INDEPENDENT REVIEW OF BASEMENT IMPACT ASSESSMENT (UPDATED)

It is proposed to construct a deep basement extending rearwards from the existing house to house a private underground gym and swimming pool.

This report has been updated following the review of additional and revised information recently submitted to Haringey by the applicant.

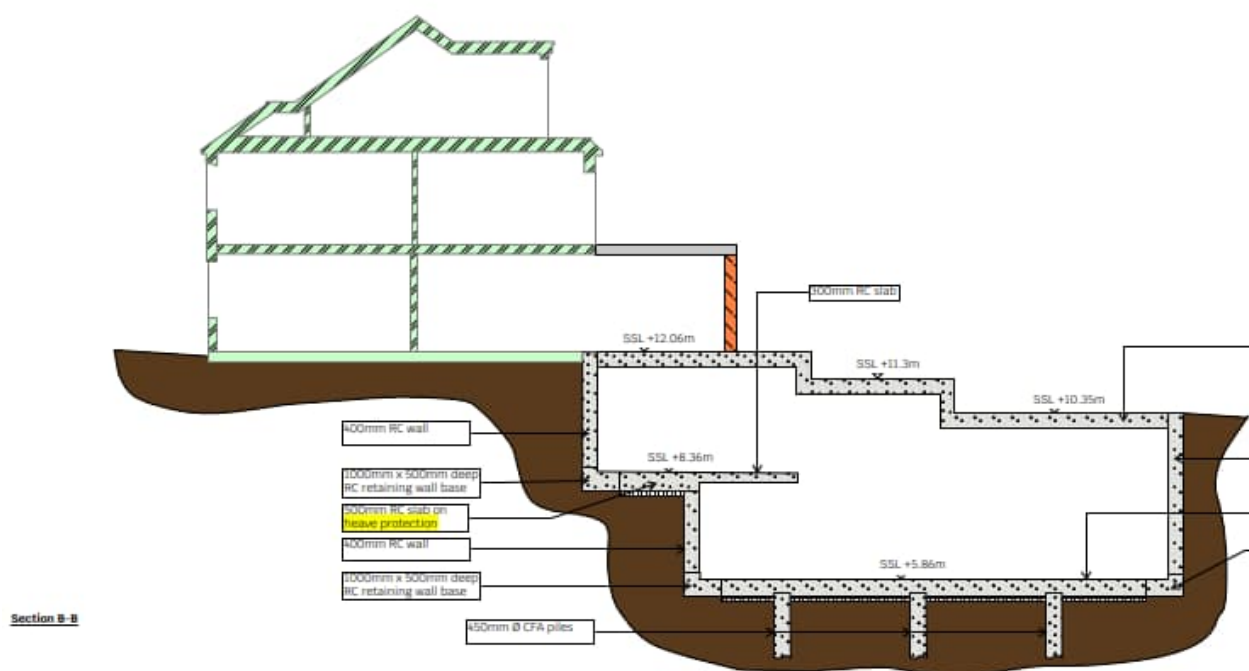
The site lies within a critical drainage area and the above BIA statement suggests a worrying lack of understanding by the applicant of hydrological matters. Even a cursory study of the surface water flood risk plan above shows that the flood risk along Cranley Gardens is ameliorated by means of the flow down through the gardens of this and the adjacent properties. Stopping up this flow will drive the flood water eastwards further down Cranley Gardens towards the already high flood risk area around Park Road and will only exacerbate the flood risk in that area.

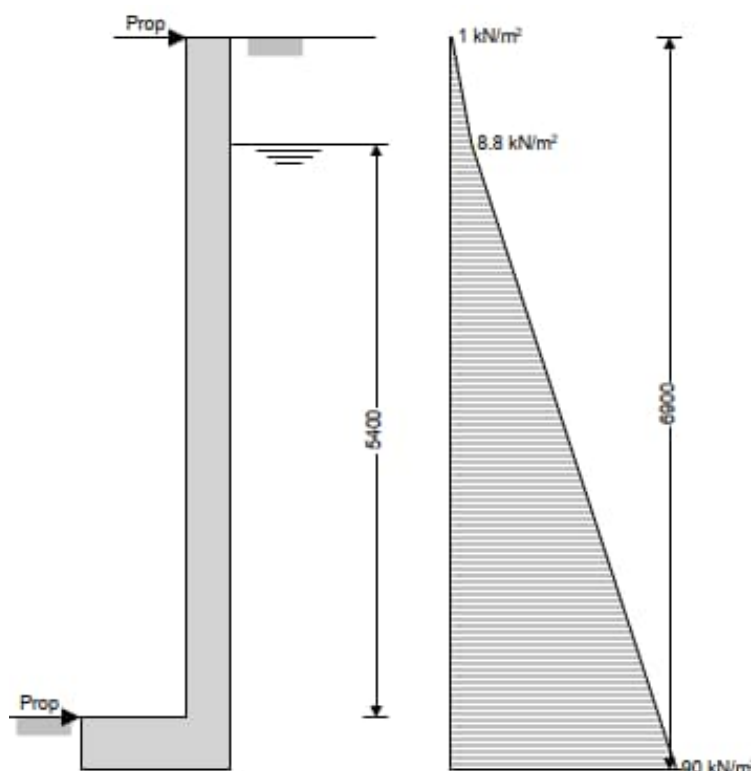
However, perhaps as a result of the lack of site investigation information indicated above and addressed further in Section 4 of this review, the one section drawn through the existing building (see below) contains no detail.

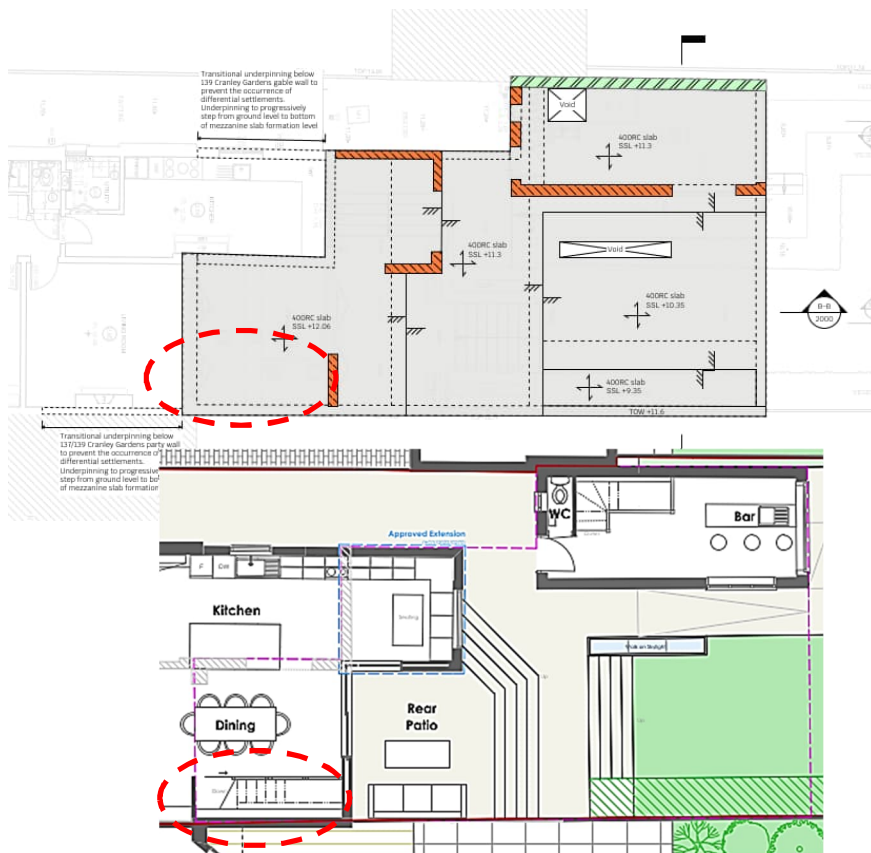
There has, as of yet, still not been much care or attention to detail put into the design of this project and one example of this is that the engineer's 400mm thick ground floor slab will obviously block the stairs shown on the architect's ground floor plan shown here.

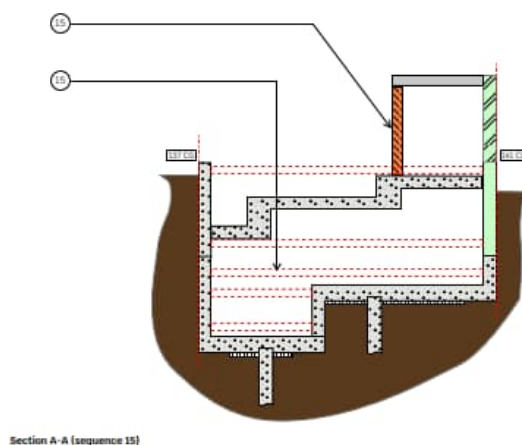
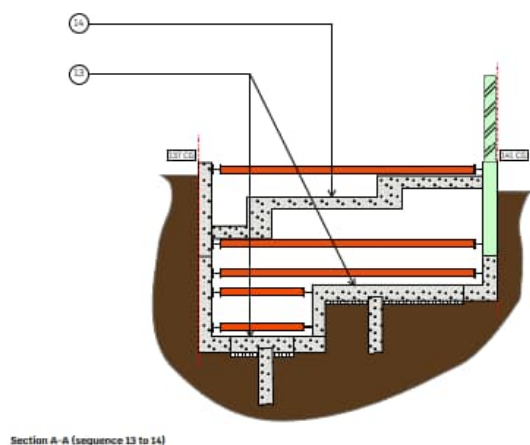
In this case the submitted retaining wall design suggests indicates that there will only be two levels of propping, one at the top of the wall and one at the base of the wall. However, there must be some questioning of the design in the light of the sections below that appear to show only a relatively low-level permanent prop that might allow increased deflection of the wall where it is cantilevered above this.

Proposed plan

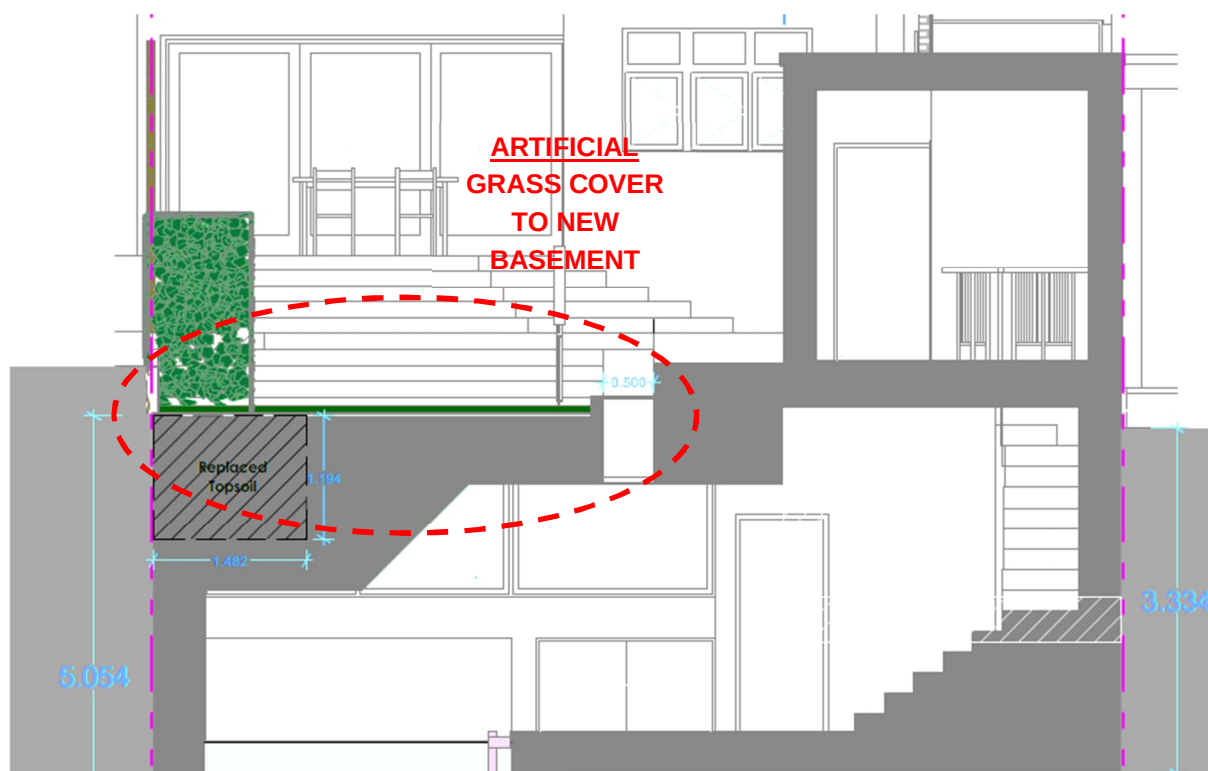
The architects design and access statement states that *"the existing garden will be fully planted and landscaped in order to provide an enhanced garden aspect to be enjoyed by the owners of No.139 Cranley Gardens alongside their neighbours."* However, the proposed plans clearly show the existing Astro turf pitch being retained and there being only a strip of topsoil positioned to support a hedge along the boundary with No. 137.

If the above drawing is incorrect and the basement is to be set 1m deeper in order to allow space for a restored garden above as required by the planning policy then this will require a rethink and re-design of the scheme.

The section above clearly shows that the full width of the property is to be excavated and replaced by the new basement. This will in effect cause the development to act as an impermeable dam to any water travelling from Cranley Road to the Cricket Ground, forcing it instead to travel down the road to the junction with Park Road, where it is understood street flooding occurred in 2021.

The site as presented in the submitted Lidar assessment (above) and as it actually is (below)

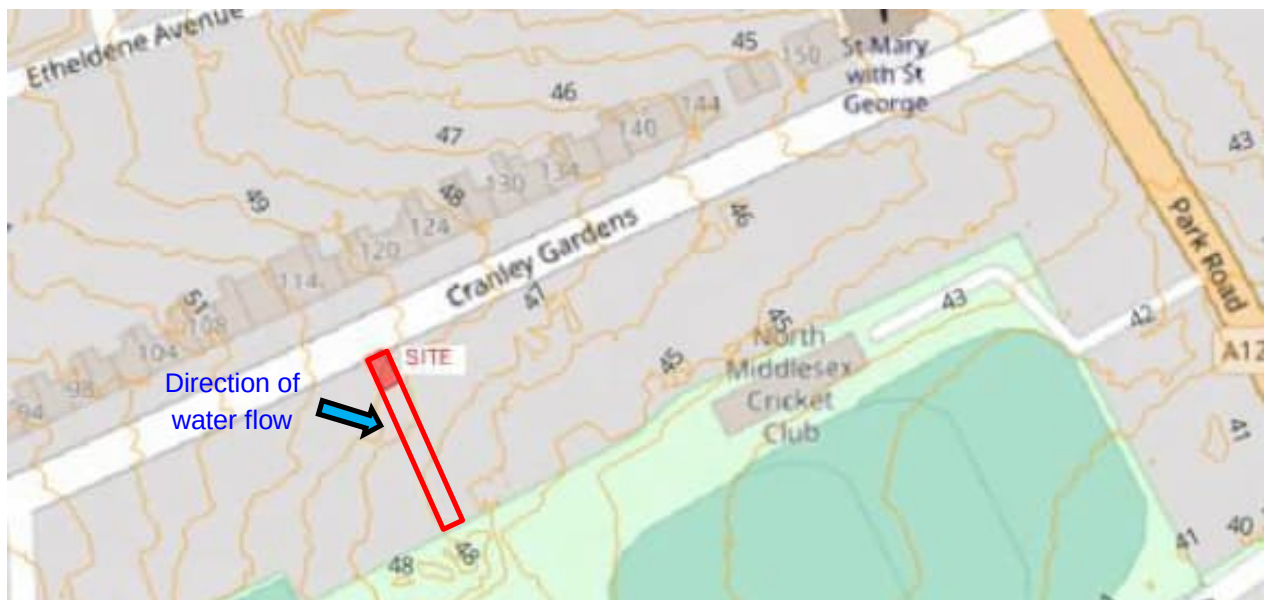
The SuDS report suggests the site to be a negligibly small area in the context of the problem area of overland flooding slope whereas the site is larger and may play a more important role in terms of hydrological impact.

It is apparent the basement will interrupt or interfere with the downslope flow of surface or near surface flow of water passing under the adjacent properties. This would inevitably affect the availability of water to the trees in the neighbouring garden to the east (No. 141) and would be expected to increase the risk of waterlogging to the rear garden of the property immediately to the west (No. 137).

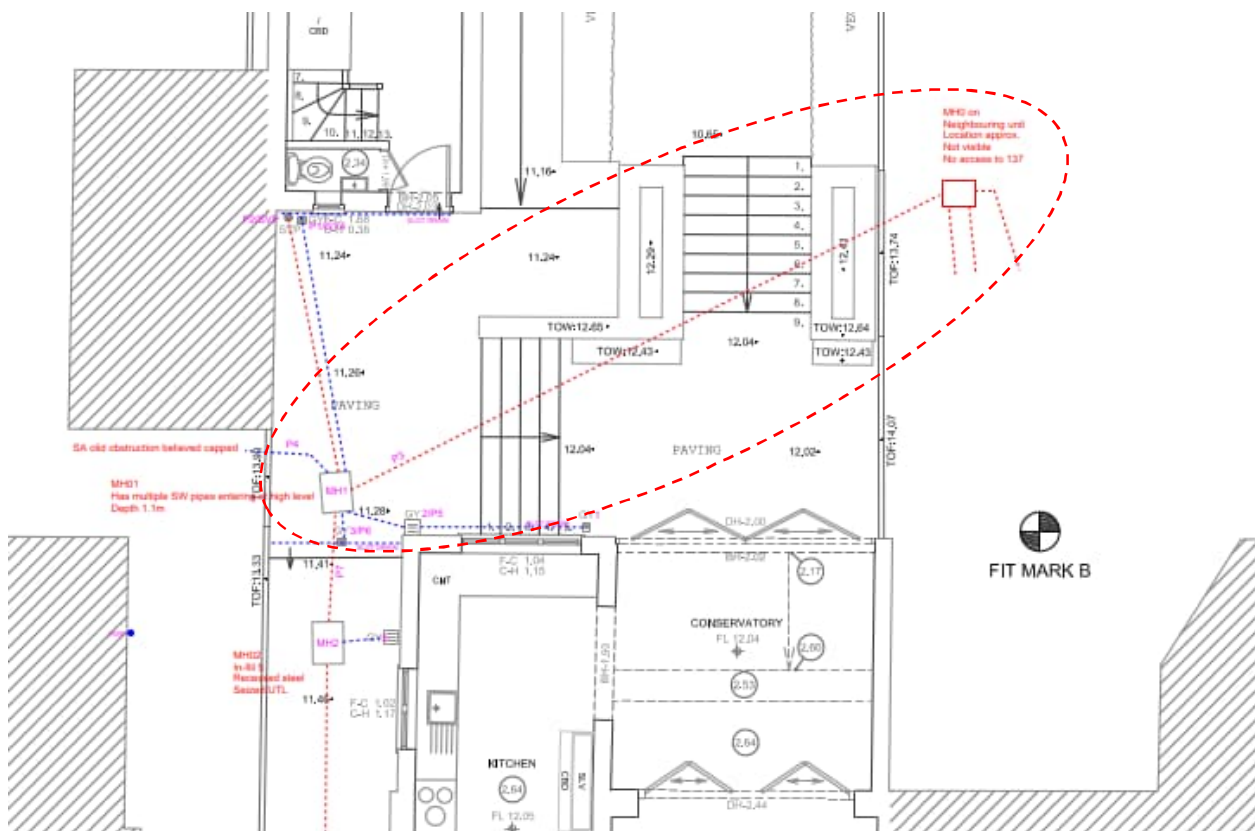
The pipe labelled P3 in plan above is an existing 100mm vitrified clay shared public combined drain that is the responsibility of Thames Water to maintain. This is an important public asset apparently serving multiple properties that, if preserved, would run mid-air directly through the proposed basement void.

It is questionable whether Thames Water would allow any diversion or replacement to occur for the sake of a house extension. They may require the extension to be substantially relocated or reconfigured in order to avoid the pipe. This issue will merit consultation with Thames Water and should be resolved before any grant of planning permission for the present scheme. There will likely also be a need for an assessment to address the potential impact of the proposed excavations and ground movements on the public sewers on either side of the new basement where these are in the vicinity of the works.
